AL80B AL572 AL800(H) Updates and Error Corrections

Rev2A 2/17/23 W8JI

Figure 1 Stock timing

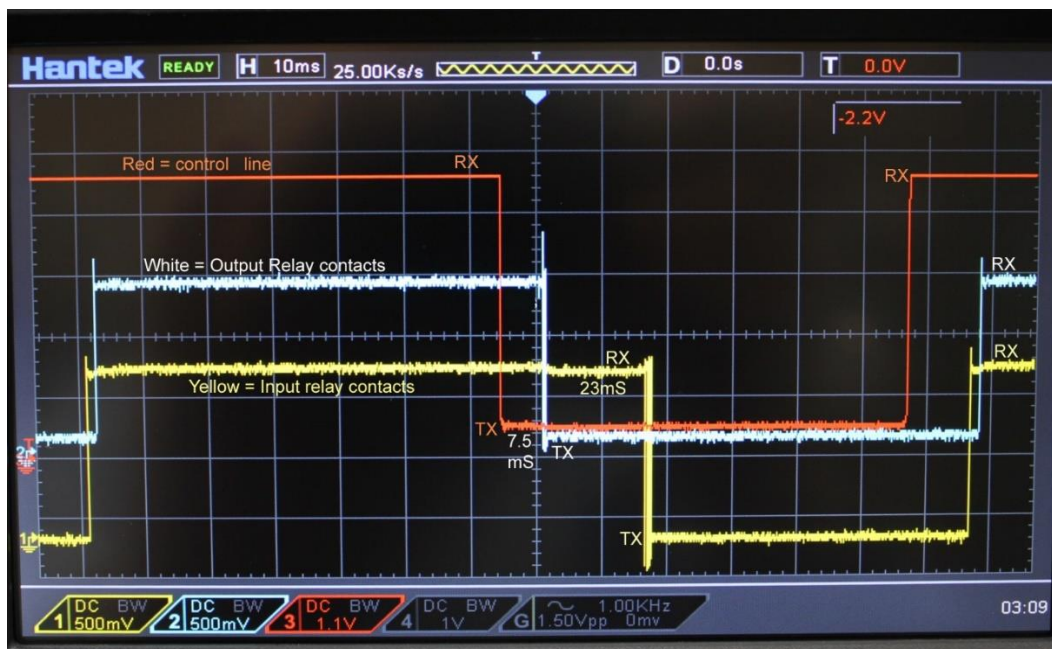
At some point, someone at MFJ modified the antenna relay system to use two plastic case miniature cube relays. MFJ-modified systems using two relays have major relay timing and keying line impedance (sensitivity) problems. The small cube or enclosed DIP relays themselves switch and settle in 6mS or less. However, MFJ circuit design errors needlessly extend relay closure into the 20-30mS region. The system should actually be in the 6mS area. Making matters worse, the relay return-to-receive is very unreliable due to major relay control line impedance errors.

Factory circuit errors in all “AL8B frames” using small enclosed relays cause shortened relay life, unreliable receive return, and grossly excessive TX delay time requirements. The basic dual relay keying circuit design is very poorly planned, but a few simple patches will make it workable.

Figure 2 modified timing

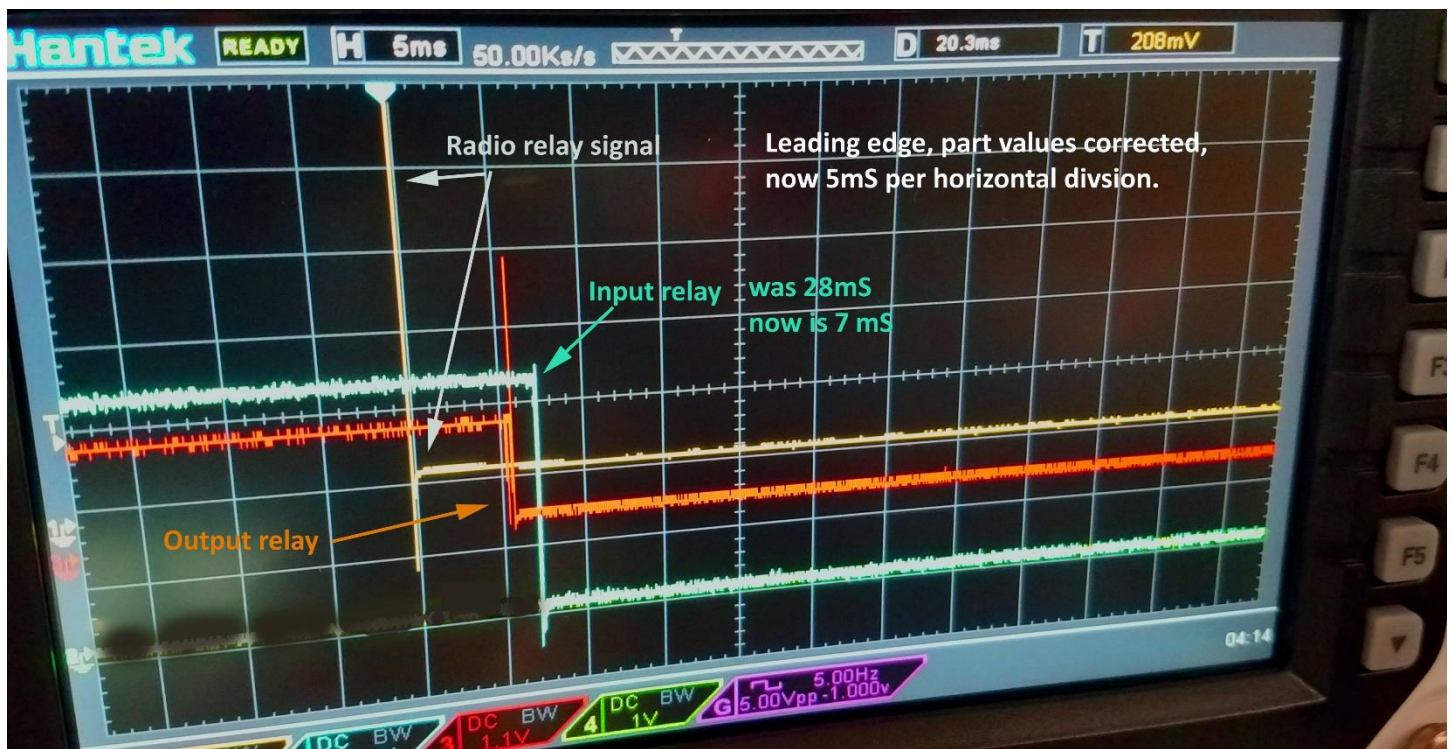
The switch to transmit time is the critical time that must be programmed into the radio. Unless the radio has a severe design defect the receive-to-transmit window is the only switching window causing hot-switching and thus the only window of concern. Figure 2 is the leading-edge (RX-to-TX) result of these changes (other issues not shown that improve relay life and receive recovery time are also corrected):

Figure 3 (plug-in relays) D116 location

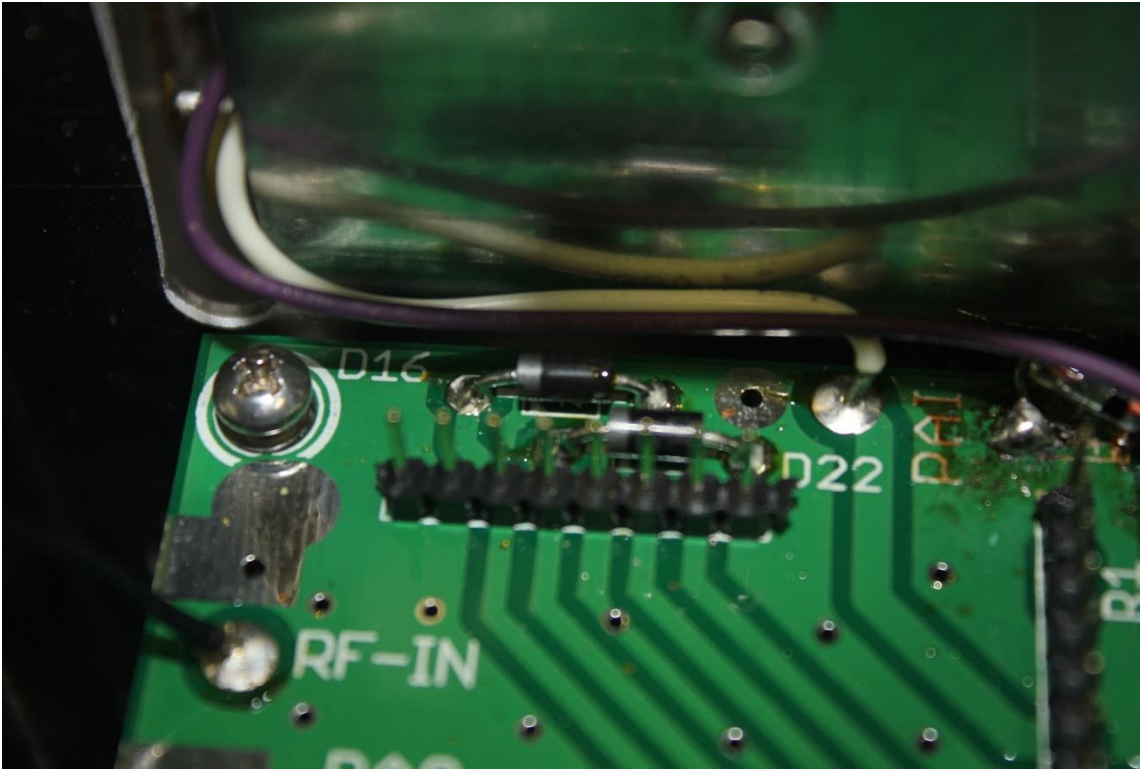
1.) Remove D116 (the board's numbering omits the leading 1 and says “D16”). D116 needlessly slows input relay return time. D116 is near the center panel rear. Plug-in relay units will need the relay board removed. Just snip either end of D116 with small cutters. There is no reason to remove D116

entirely so long as it is disabled by snipping a lead. D116 is the diode with zero ohms continuity from Q106 emitter to D116 striped end (cathode).

Figure 4 Zener and resistor mod

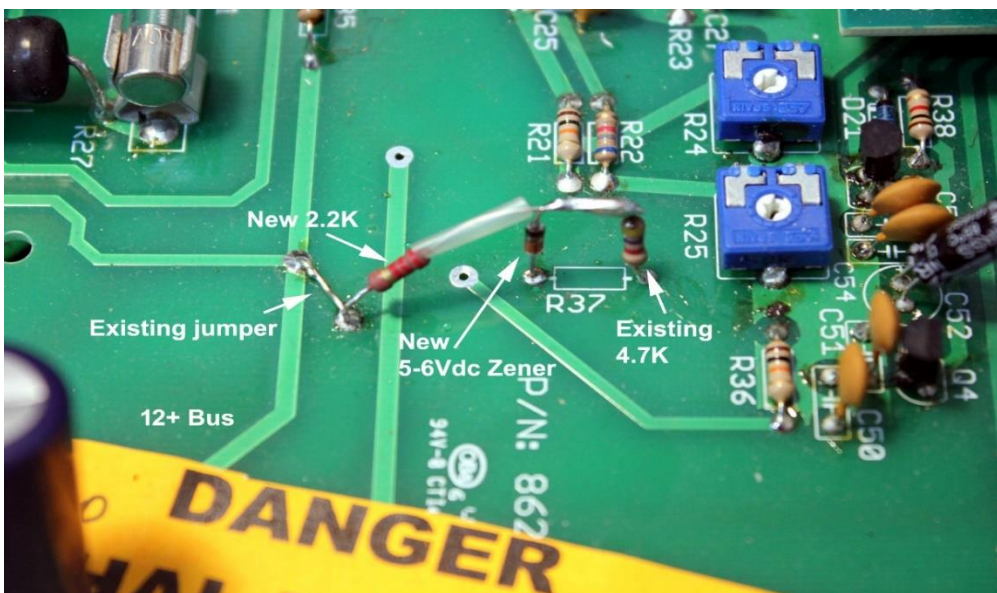
2.) Unsolder and lift the **RLY jack end** of R137 4.7k from the circuit board pad. It is a good idea to first re-wet or reflow that solder connection with regular 60/40 solder. Be careful to not overheat the pad and lift it.

- 3.) Referring to figure 4, the new 5.6Vdc Zener diode connects with the banded end up to the end of the 4.7k lifted in step 1. This diode makes the threshold voltage on the relay control jack more reasonable at normal logic levels.
- 4.) A new 2.2K resistor bridges from the ~12Vdc control line voltage bus to the junction of the Zener banded end and the lifted end of R137. This resistor reduces the relay control line impedance to a more reasonable level of a few thousand ohms, making receive return more consistent.
- 5.) Radial lead 10uF C152 (sometimes listed in parts as C153 while labeled C52) needs removed and replaced with a .33uF to .47uF capacitor. This capacitor largely causes the significant transmit timing problem in dual relay amplifiers.

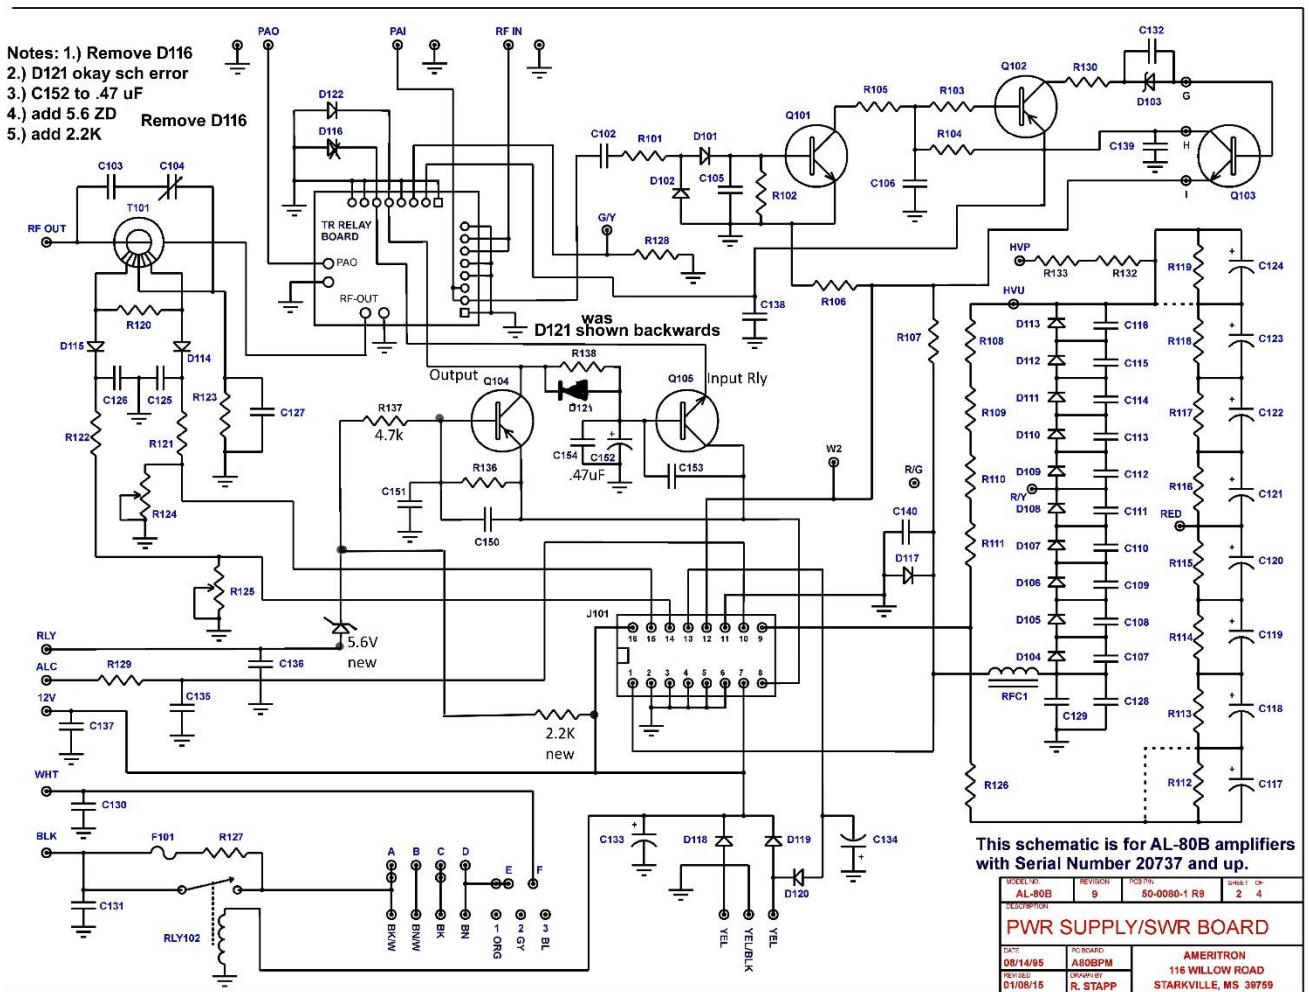
The reworked relay system now looks like this (note that D121 is drawn backward in some or all MFJ schematics, although D121 is usually installed in the correct direction as mounted in the circuit board):

Figure 7 bias changes

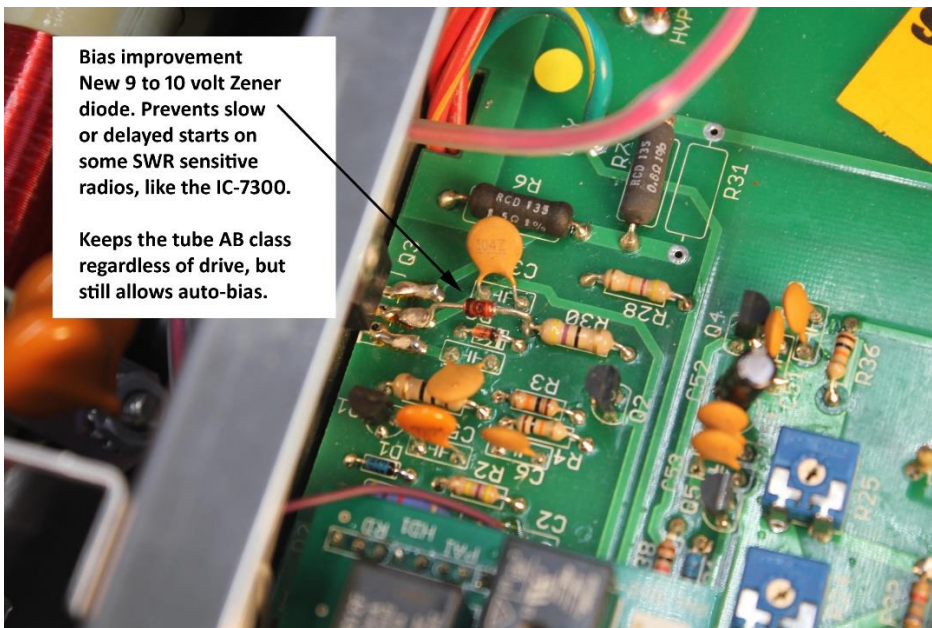
- 1.) Add 9.6V Zener diode from either side of R130 to collector (middle terminal) of Q103, banded end to Q103. The Zener can sit up in the air a little.

- 2.) Tack-in a new 0.1uF capacitor from junction of R103, 104, 105, and C106 to ground. You may want to clean up some of the MFJ soldering while working on the amplifier. This one has not

Figure 9 Corrected PS Schematic All Mods

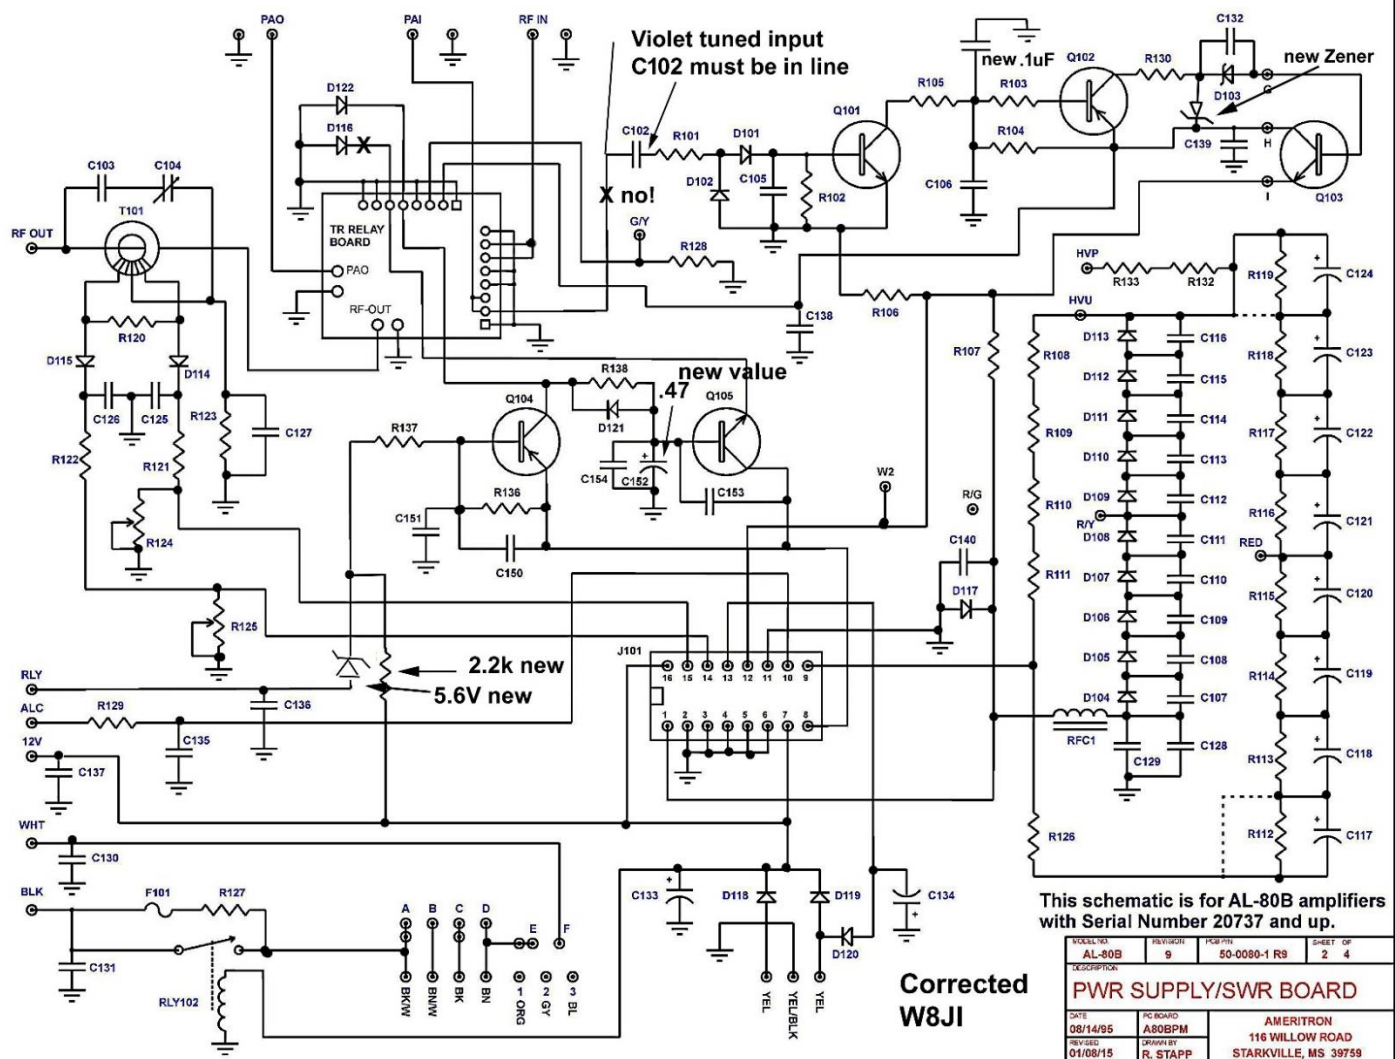
Corrected Schematic All Mods

Figure 12 pre tin GDT leads

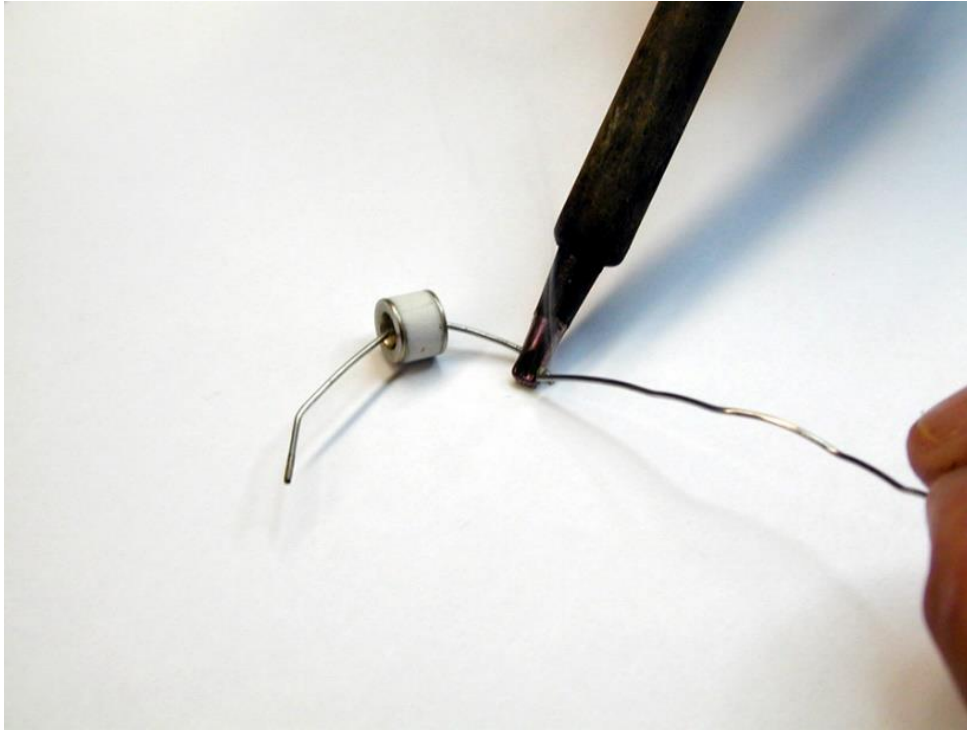
2. If missing, add two GDT's, one from each side of filament system from filament pins to ground plane of board. Be sure to stay clear of holes. Pre-tin all the parts and connection points with fresh 60/40 solder

Figure 14 Sweat on GDT

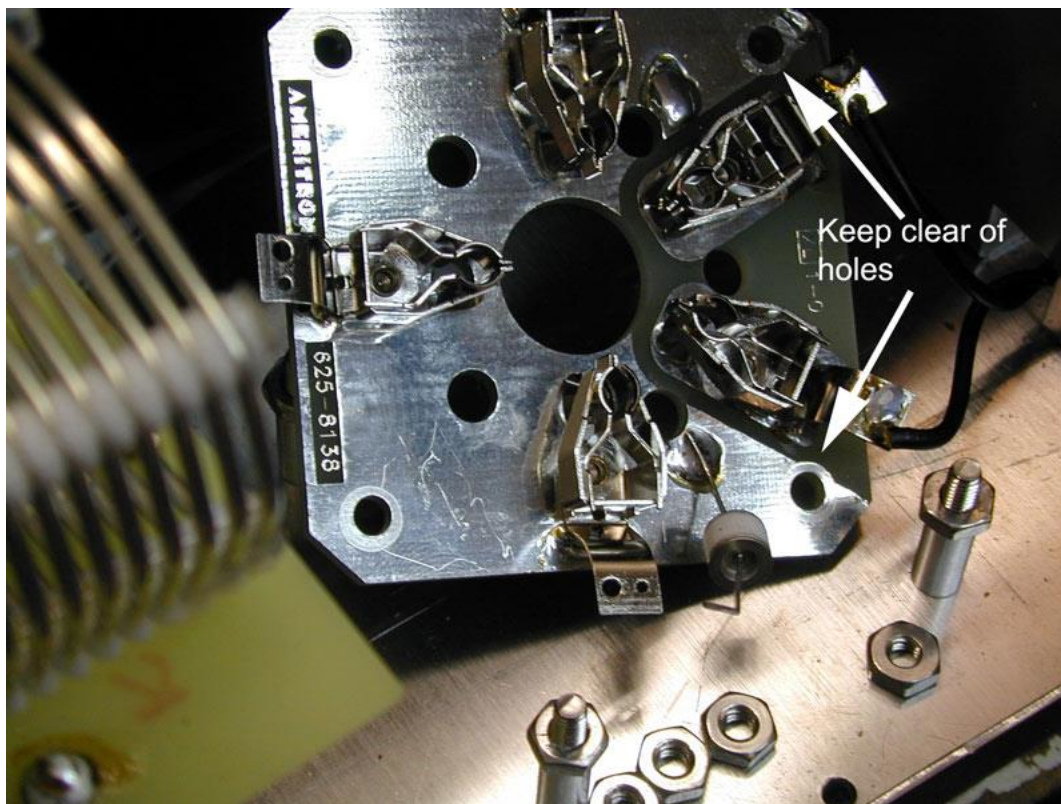
3. Attach GDT to socket by sweat soldering. Solder to ground plane first

Figure 15 no shorts

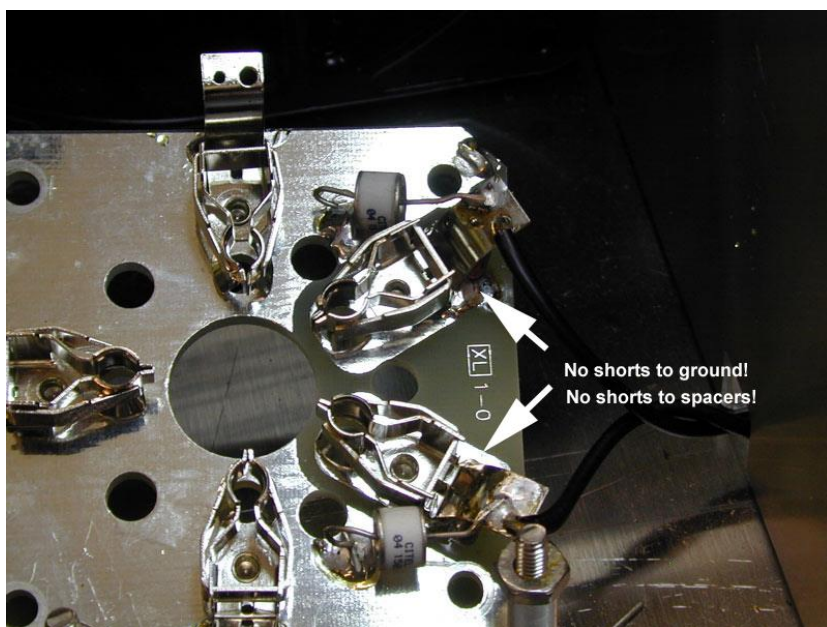
4. Final socket with GDT ready to reinstall. Be sure GDT's clear chassis and socket mounting hardware.

Figure 17 Bottom view SWR transformer error

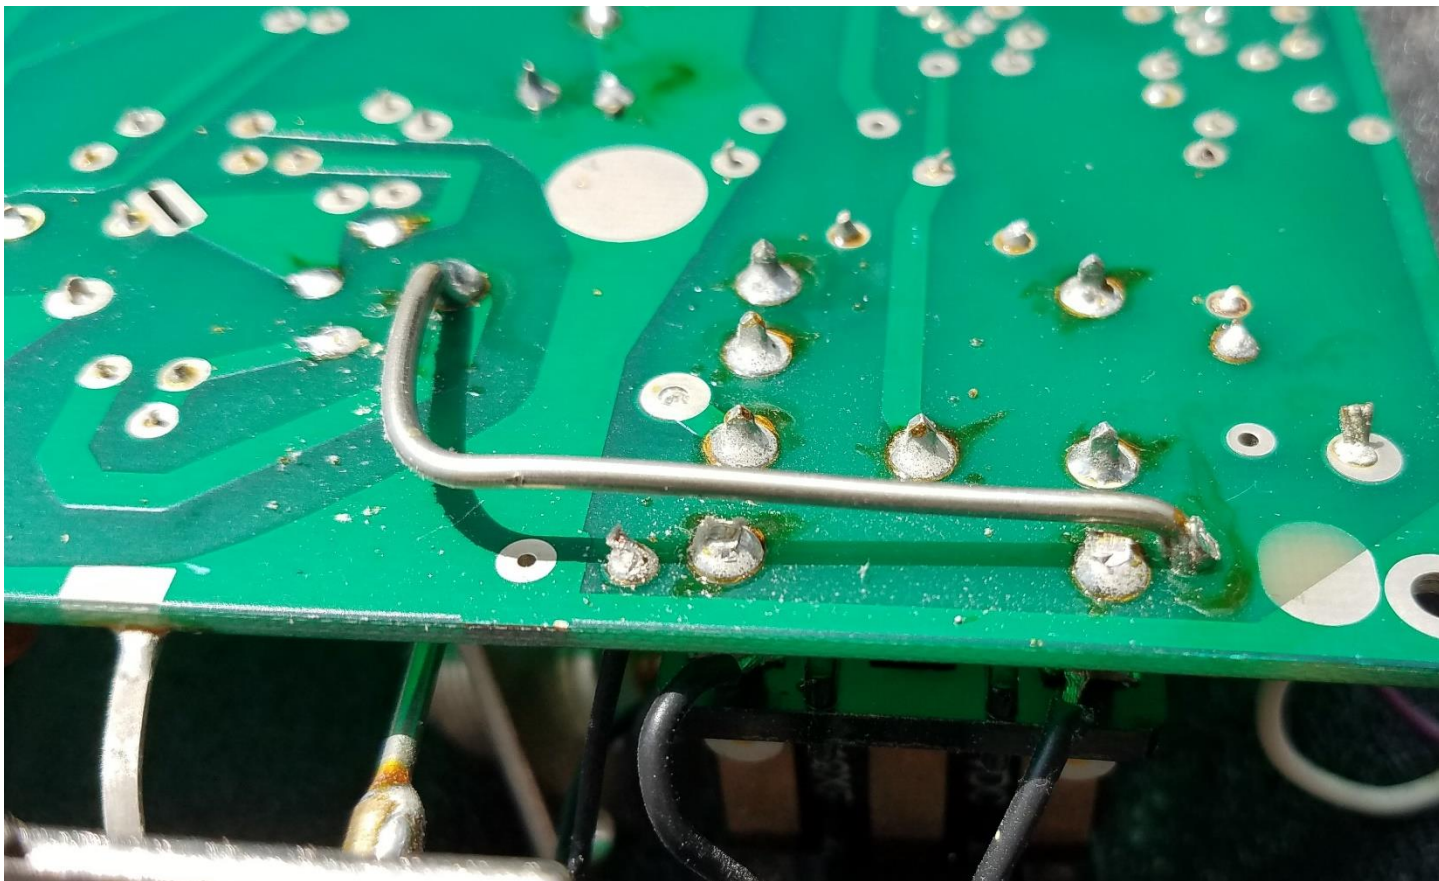
I recently discovered that years ago, despite conversations, emails, and documents to MFJ in the design stages, a layout person changed the main circuit board in the current transformer area. The problem is someone made the shield eyelet hot with RF. The brass eyelet was always supposed to just fit inside the pickup coil and be grounded. The RF was supposed to pass through the eyelet using a Teflon insulated wire. This error is all units in the AL8X frame, including the AL800, AL800H, AL572, and AL80B units

Someone at MFJ negated all that by making the eyelet hot, common with the center conductor. Compounding this error, MFJ sometimes uses cheap regular plastic or nylon insulators to isolate the electrically hot eyelet from the pick-up coil instead of Teflon. Even a Teflon bushing is not a good cure, and nylon is much worse.

I have not found a simple fix yet for this error, other than removing the feed wire and eyelet, gluing the transformer down with RTV, and passing a Teflon insulated wire through the transformer. This unfortunately is the most difficult factory error to correct.

The bare buss wire could be replaced all the way through the transformer with a Teflon insulated 18-gauge wire, but this is likely well beyond most field repair. I hope to eventually have a board that can be scabbed in to correct this problem. It is on my list.

A new detector board is the only field solution I can think of.
